# **SPECIFIC DEFECTS REPORT**

# Relating to front and rear extension work at XXXX XXX Surrey XXX

We have been asked to provide an independent report with regard to front and rear single storey extensions that have been built at XXXX Surrey XXX

No drip detail to the front of the coping stone allowing water ingress

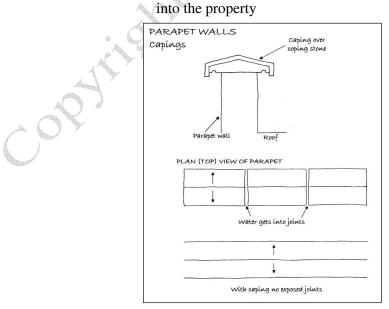
1.2.4) The coping stones do not have a drip detail and we are advised do not have a DPC (damp proof course) detail (the latter would only be a hundred per cent confirmed

1.3.1) Has a cavity tray been installed?

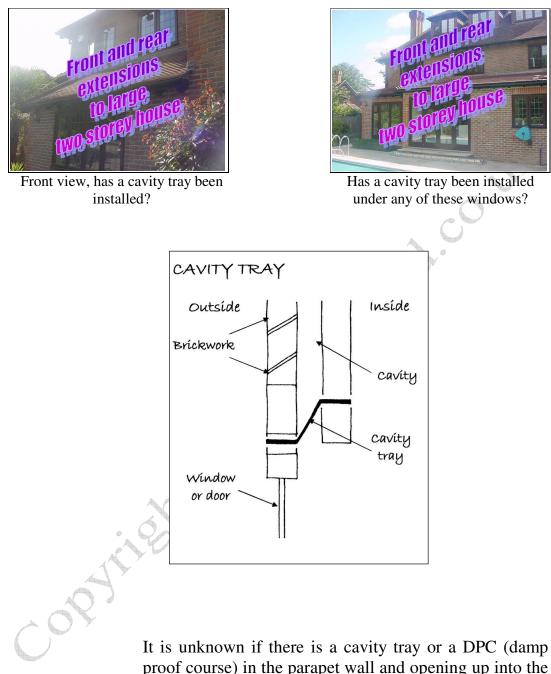
Where the new opening have been formed in the building the cavity tray typically needs to be installed to transfer any dampness that gets into the property from the walls back out.

### 1.3.2) Movement

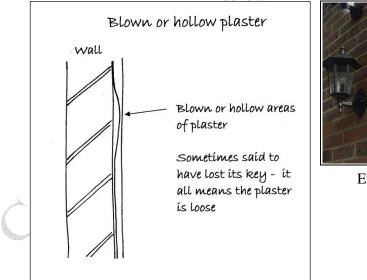
We are advised that the movement has occurred in the property when the walls were opened up. It is unknown if this movement that is visible in the plaster has caused structural damage to the property in the long term. Further investigations required.
